Subject: DIFFICULT TO MOVE SELECTOR LEVER OUT OF "P" RANGE	Bulletin No: 05-010/14
	Last Issued: 10/03/2014

2010-2015 CX-9

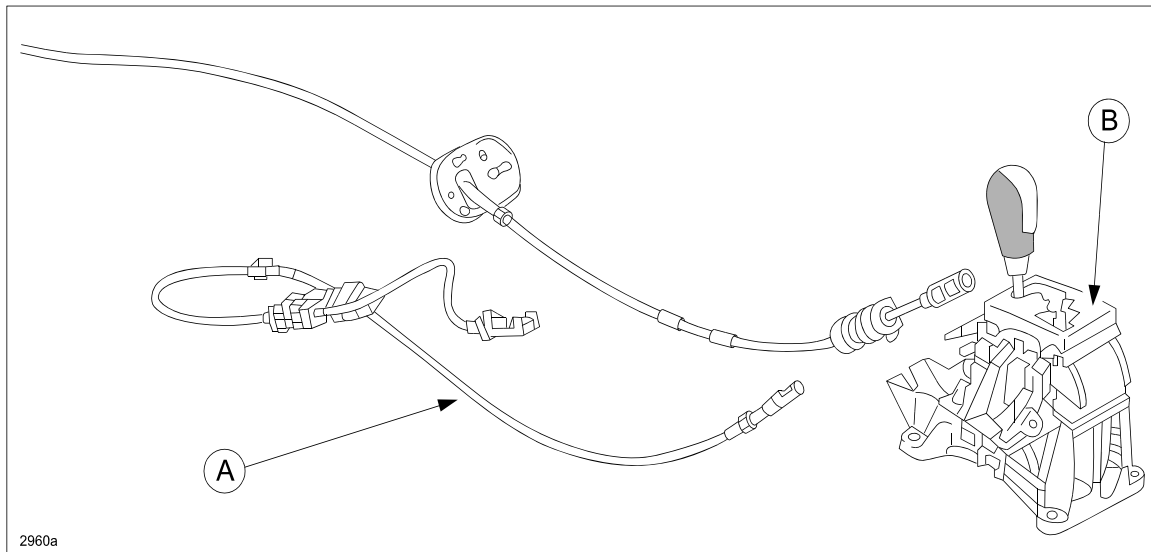
Some customers may experience difficulty moving the selector lever out of "P" range after the vehicle has been parked overnight in extremely cold temperatures (i.e. below freezing). The selector lever movement may return to normal after running the climate control system at maximum hot for short period of time.

This concern may be caused accidentally by the customer spilling a drink around the selector lever. When the spilled liquid reaches the interlock cable and freezes overnight, it causes the customer to have difficulty moving the selector lever out of "P" range the next morning.

1. Verify the customer concern.
2. Replace the interlock cable (A) according to the instructions on MS3 online or the Workshop Manual (section 05-18 AUTOMATIC TRANSAXLE SHIFT MECHANISM REMOVAL/INSTALLATION).

Protector Installation Procedure:

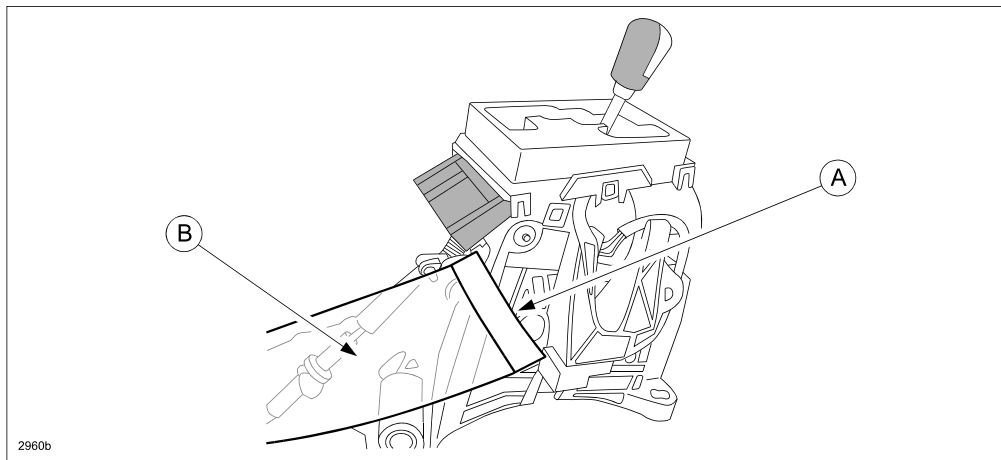
1. Peel off the backing film (A) from the protector (B).

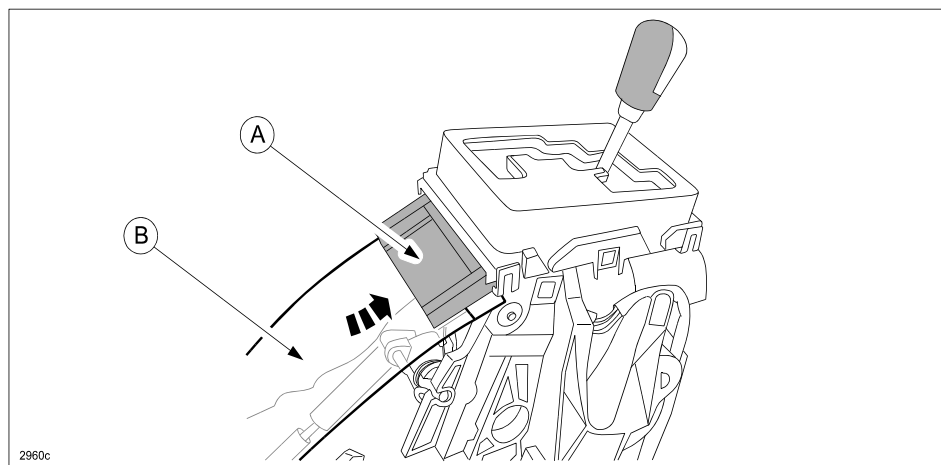
2. Attach the protector (B) under the protruded area (A) of the selector lever (as shown below).

NOTE: Install the protector correctly, referring to the “Protector Installation Note” below.

Protector Installation Note:

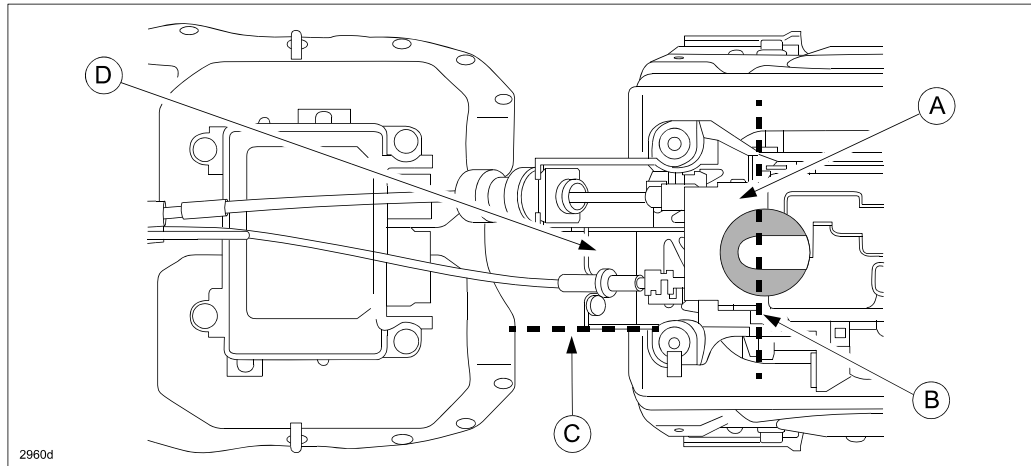
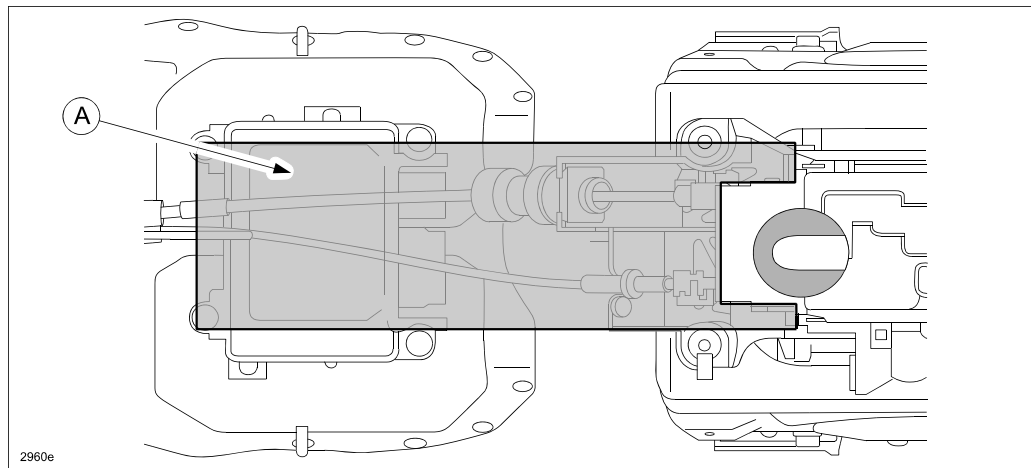
1. Insert the protector under the protruded area (A) all the way to the vertical line (B) shown below.
2. Align the side edge of the protector with the edge (C) of the bracket (D).

Before Protector Installation (Top View):

After Protector (A) Installation (Top View):
